WSSA Critique of Bellevue SMP Open House

Washington Sensible Shorelines Assoc. has prepared the following critique of Bellevue's draft SMP regulations as portrayed by staff at the April 20, 2011 City Open House. WSSA notes a number of discrepancies and clarifications.

Existing Docks - Replacement

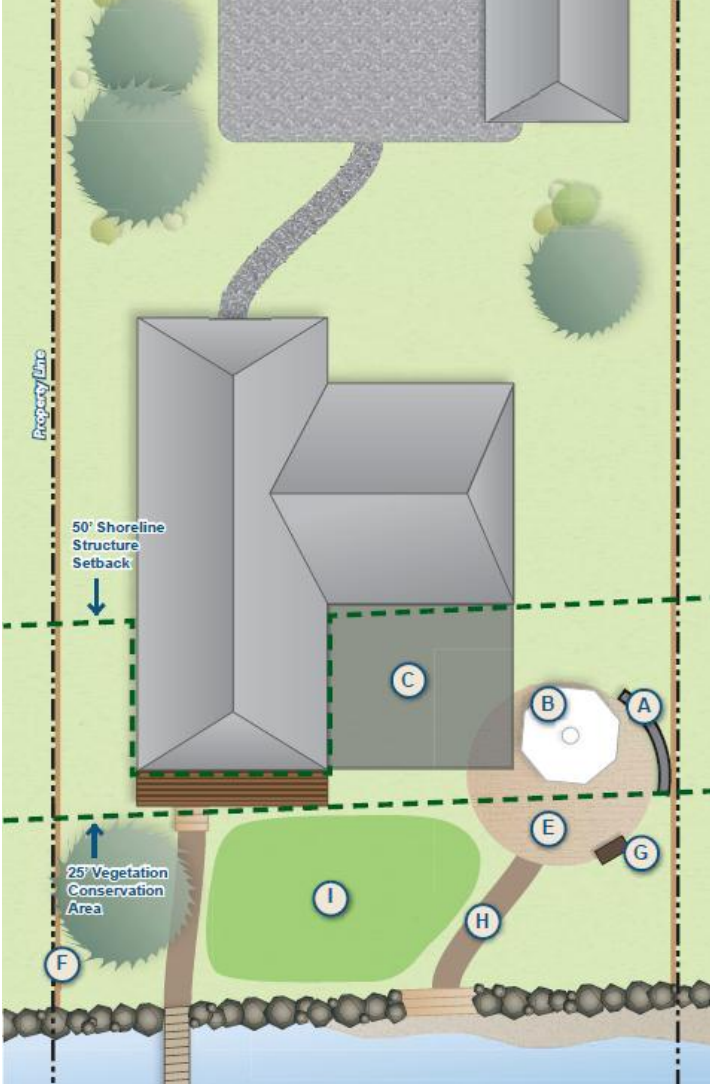
If reaching 30 ft has the pilings in 20-30 ft of water, will the dock be stable?

Why does one need to “buy-back” a safe width of walkway by reducing ones moorage platform?

Has it been established that this pile arrangement will be stable?

NOTE – mitigation options were not defined.

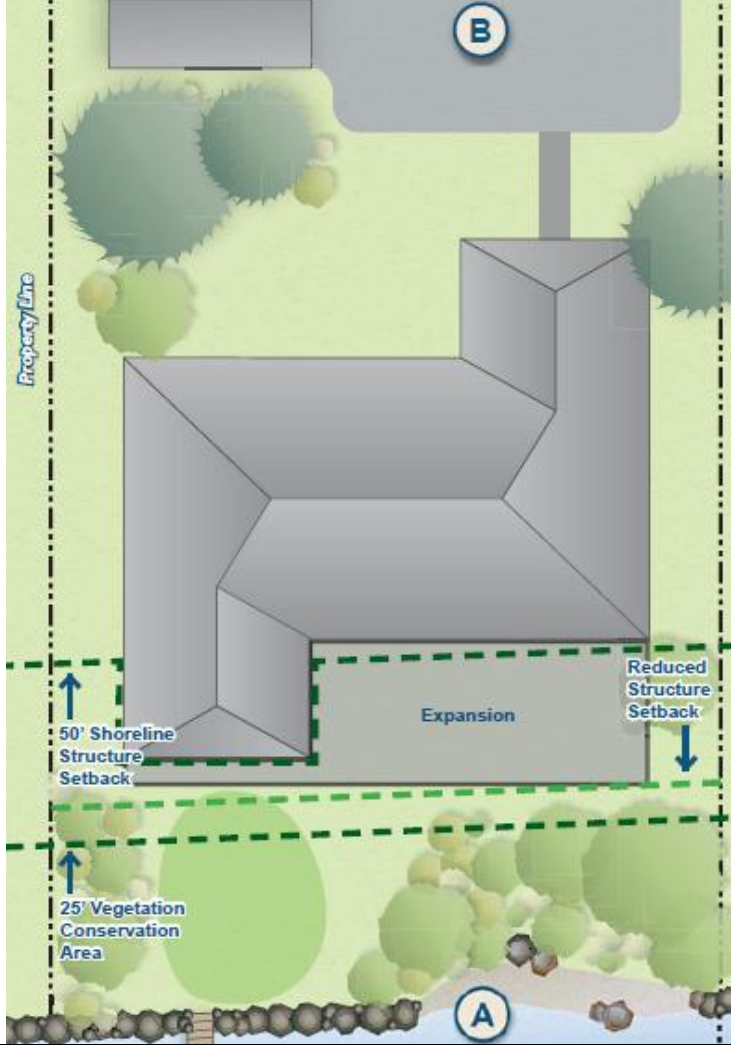
<p data-bbox="613 1900 852 1932" style="text-align: right;">CONTINUED BELOW</p>	<p data-bbox="1047 1264 1453 1327">A – Retaining walls closer to shore will be subject to regulation.</p> <p data-bbox="1047 1369 1461 1474">B – Code states accessory structure changes require onerous setback reduction options.</p> <p data-bbox="1047 1516 1437 1621">C – Additions must be <u>lateral</u> or else requires a setback reduction option.</p> <p data-bbox="1047 1663 1461 1768">D – Impervious surface includes dwelling expansion. Over 1000 s.f. triggers additional regulations.</p> <p data-bbox="1047 1810 1461 1873">E – 40%’s arbitrary. Engineering & bond required to assure ‘pervious’.</p> <p data-bbox="1047 1915 1437 1978">F – Fences allowed only to 25 ft from shoreline; thus are useless.</p>

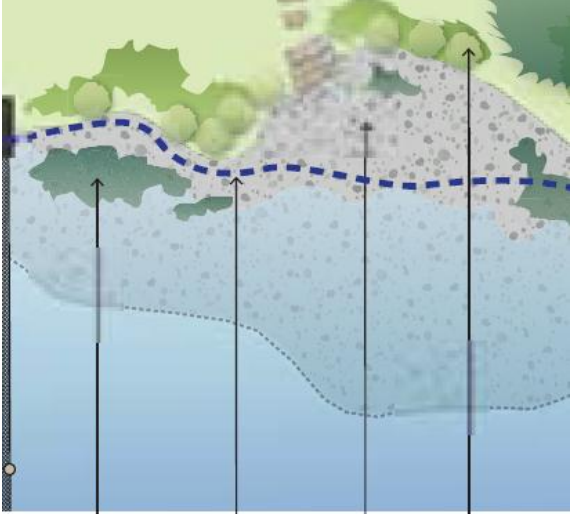
City Display	WSSA Critique
<p data-bbox="94 212 350 243">New Development</p>  <p>The diagram illustrates a proposed 'New House' development. It shows a large house with a driveway and a retaining wall. A '50' Shoreline Structure Setback' is indicated by a dashed line. A '25' Vegetation Conservation Area' is shown as a green area with trees. A 'Pile pit' is marked near the retaining wall. A 'Path' leads from the house to the shoreline. An 'Access structure' is shown near the shoreline. A 'Lawn' area is also depicted. Red arrows point from the critique text to the diagram, highlighting non-compliance with proposed rules.</p>	<p data-bbox="1045 285 1448 359">What restrictions would there be?</p> <p data-bbox="1045 401 1159 432">Answer:</p> <p data-bbox="1045 443 1398 474">You will need to locate to -</p> <ul data-bbox="1045 485 1448 705" style="list-style-type: none"> - avoid need for a bulkhead - avoid proximity to shore - minimize topographic change - dedicate 60% VCA on shore - plant native vegetation & trees <p data-bbox="1045 747 1377 779">AND, you will need to. . .</p> <p data-bbox="1045 789 1182 821">Agree to –</p> <ul data-bbox="1045 831 1419 1052" style="list-style-type: none"> - a maintenance bond - record VCA on title - replace trees at 3:1 ratio - leave trimmings for habitat - use only hand tools & hand labor. <p data-bbox="1045 1104 1463 1325">This diagram does not comply with the proposed rules. The planted areas cannot be split as shown here and these are tall trees, blocking views, and they will be prone to toppling.</p>

<p data-bbox="107 1404 607 1509">Draft standards for new construction:</p> <p data-bbox="126 1514 691 1545">Shoreline structure setback = 50 feet</p> <div data-bbox="159 1549 704 1724"> <ul style="list-style-type: none"> » Landscaping standard: plant 60% of Vegetation Conservation Area » City-wide tree preservation standard » Retain existing native vegetation in Vegetation Conservation Area </div> <p data-bbox="126 1734 610 1776">Setback may be reduced using:</p> <ul style="list-style-type: none"> » Menu options » Special Shoreline Report » Variance <p data-bbox="94 1892 334 1923">CONTINUED BELOW</p>	<p data-bbox="1045 1472 1442 1629">These sites should be allowed to develop without unjustified setbacks and burdensome vegetation requirements.</p> <p data-bbox="1045 1787 1435 1902">More time and money! Requires Dept of Ecology approval, which rarely occurs.</p>

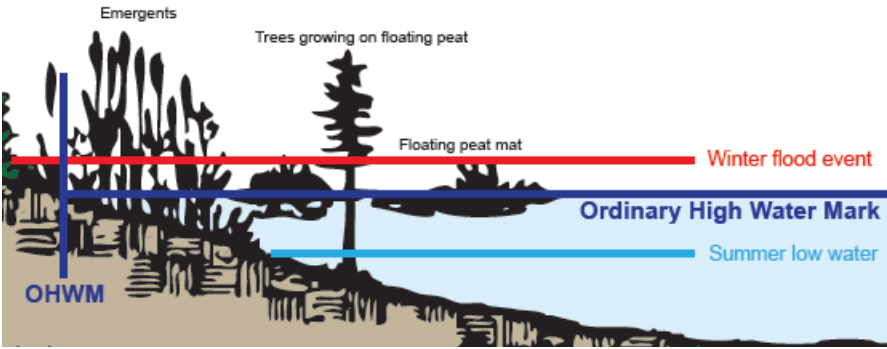
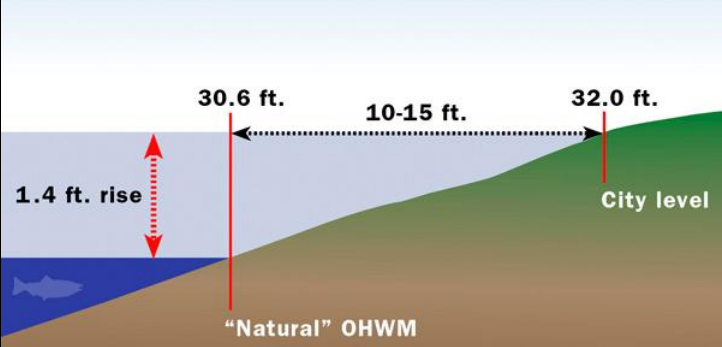
City Display	WSSA Critique
<p>New Stabilization – “Avoidance Not Feasible” – Option 2 – Rock & Wood</p> <p>Action – Place semi-natural arrangements of rock and wood, with transition to neighbors bulkheads.</p>	<p>See comments above. They apply equally here.</p>
 <p>The diagram illustrates a cross-section of a shoreline stabilization project. On the left, a vertical bulkhead structure is shown. To its right, a dashed blue line indicates the Ordinary High Water Mark (OHWM). Further right, a semi-natural arrangement of rock and wood is depicted. Labels with arrows point to specific features: 'Emergent vegetation' points to a green plant near the bulkhead; 'OHWM' points to the dashed blue line; 'Gravel' points to a light-colored, textured area; and 'Shrubs' points to a darker, textured area further right.</p>	
<p>New Stabilization – “Avoidance Not Feasible” – Option 3 – Rigid Structure</p> <p>Action: Place semi-natural arrangements of rock and wood, with greater rigidity to protect primary structure and adjacent properties. (Including logs)</p>

<p>Feasibility Study</p> <p>Required to demonstrate avoidance or soft approach is infeasible. Hard stabilization is not allowed when avoidance or soft approach is possible.</p>	<p>See comments above. They apply equally here.</p>
